HISTORIC AND DESIGN REVIEW COMMISSION

Agenda Item No: 23

HDRC CASE NO: 2016-167
ADDRESS: 1441 SE MILITARY DR
LEGAL DESCRIPTION: NCB 7657 BLK LOT W IRR 447.39 FT OF P
ZONING: C3NA H RIO-5
CITY COUNCIL DIST.: 3
DISTRICT: Mission Historic District
APPLICANT: Jason Feuge/MDN Architects, Inc
OWNER: Security Service Federal Credit Union
TYPE OF WORK: New Construction

RE: HDRC Response to Recommendation
SSFCU
1441 SE Military Dr.
San Antonio, TX
Mdn Project No. 2015075

4 WINDOW TYPES

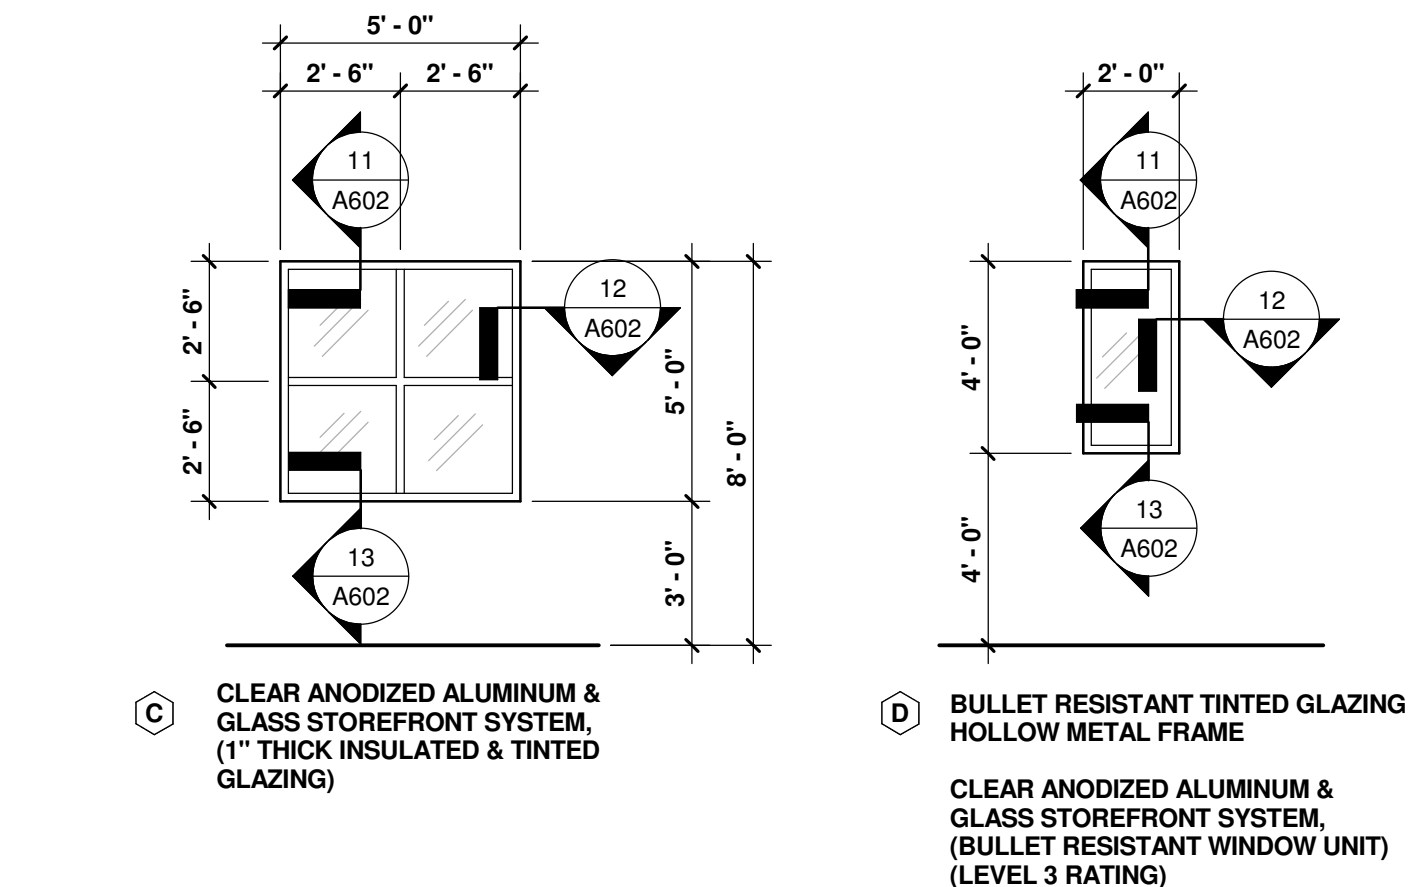
6. That the applicant provide information regarding window materials and a detailed wall section noting that all windows have been inset in walls at least two (2) inches as noted in finding o.

Response: *Please see the window detail sheet as well as the elevation sheet regarding the window details and the required 2" recess. (Sheet A201 & A602)*

E101

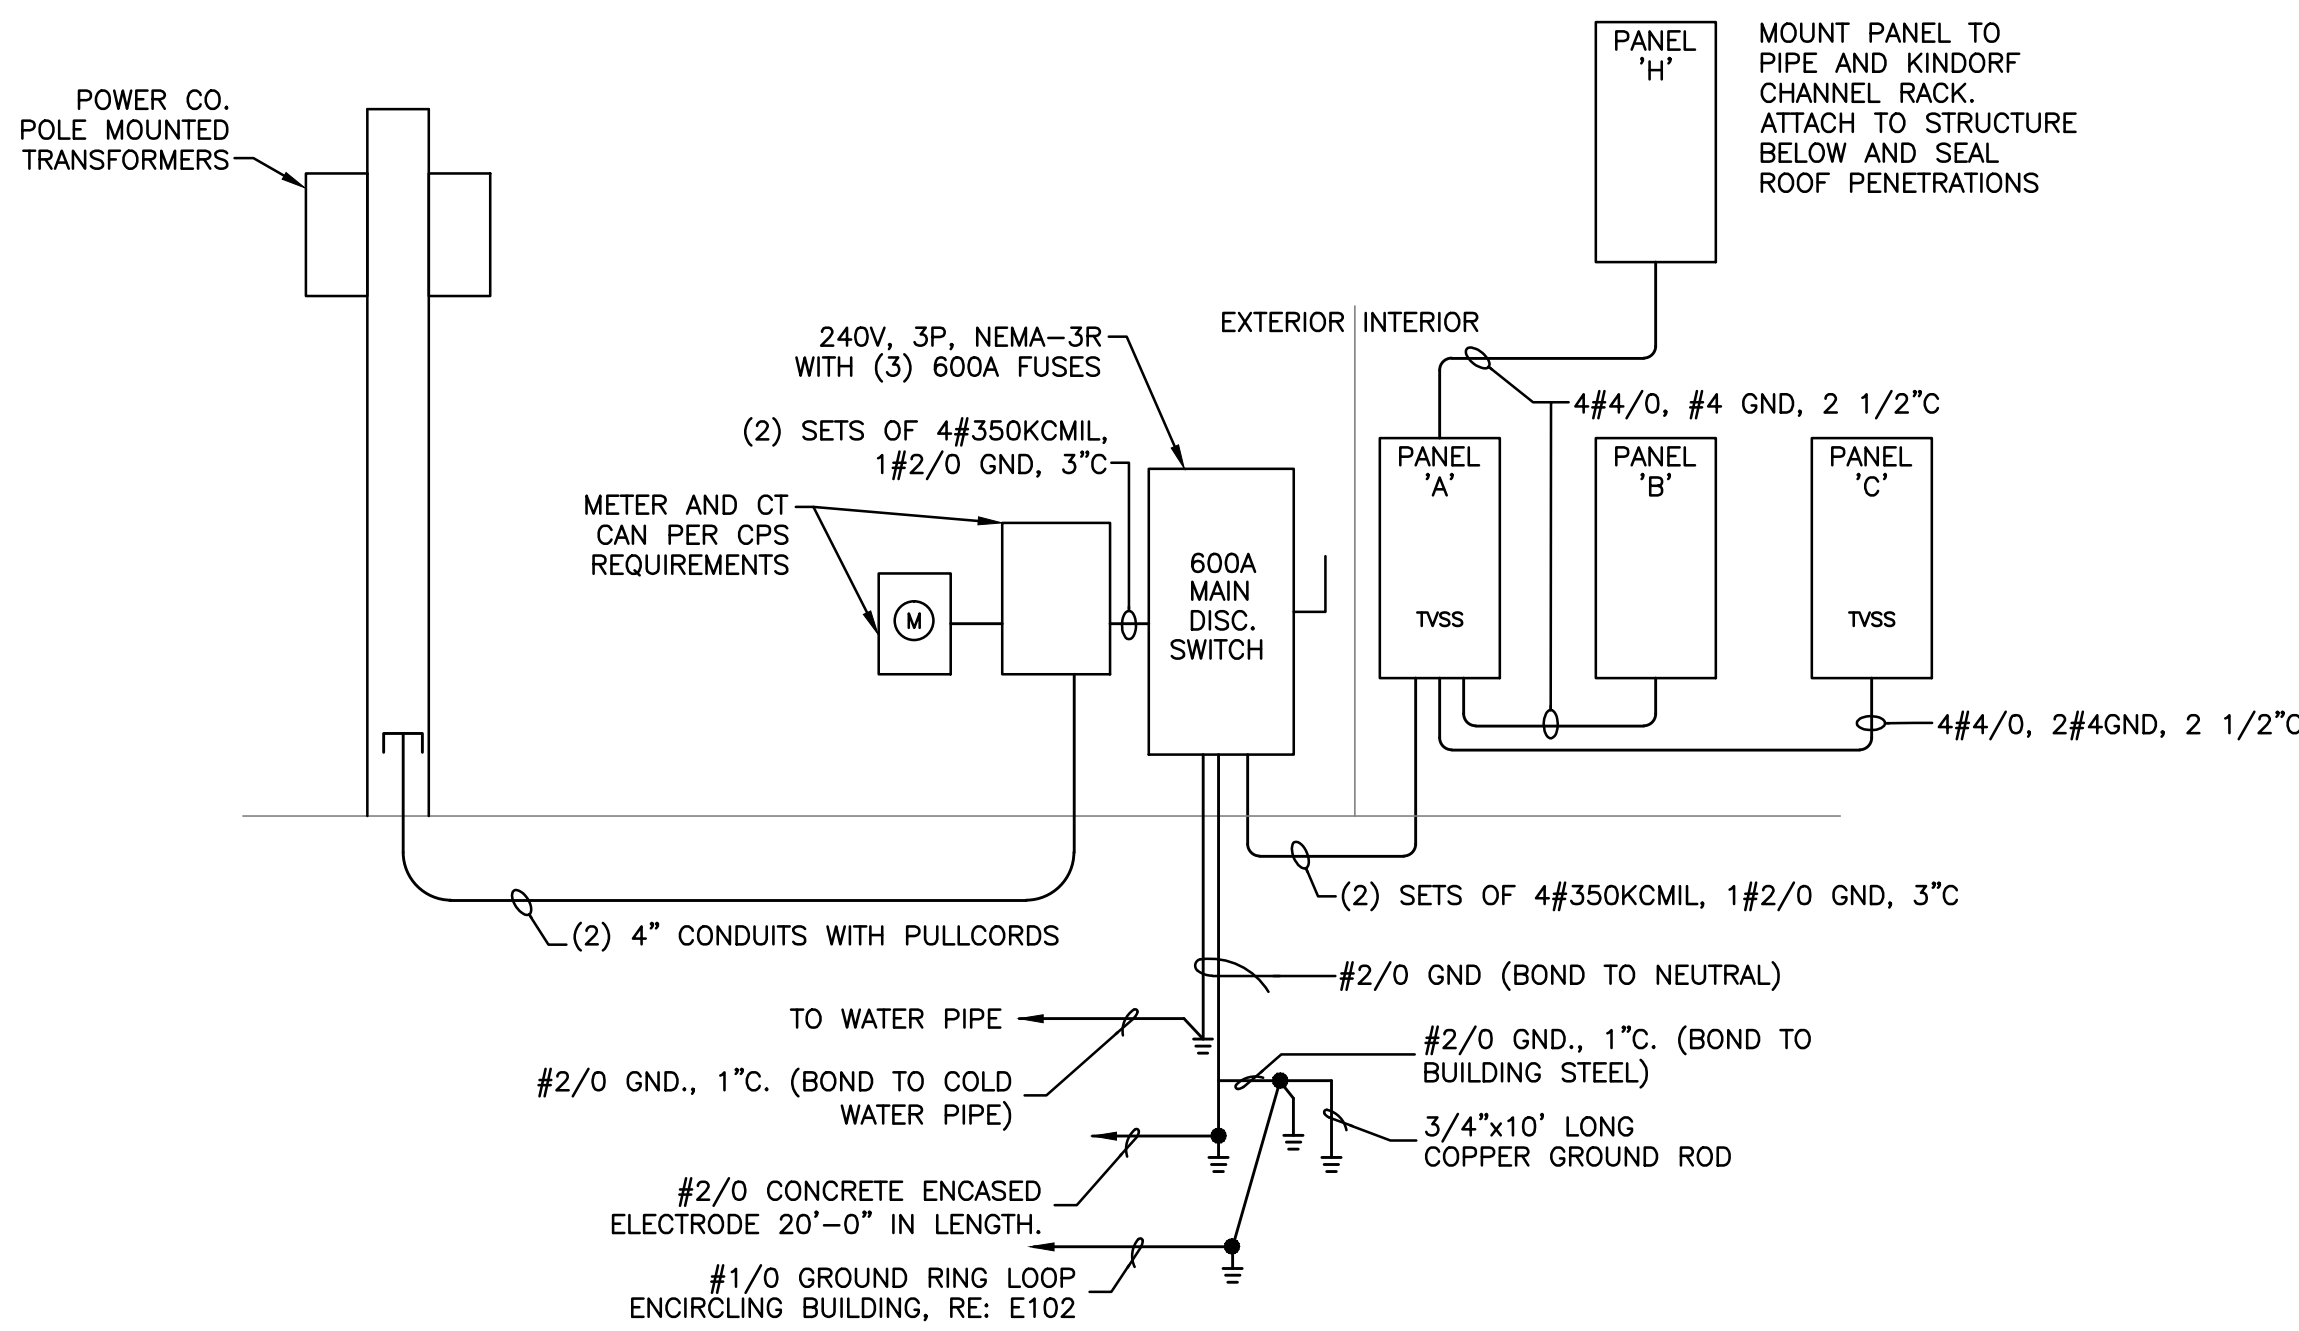
7. That the applicant provide a landscaping and site and architectural lighting plan as noted in finding q.

Response: *We have provided the City of San Antonio approved Landscape plan with details, as well as the site lighting plan for the overall site. (Sheet L1-L4 & Sheet E101)*
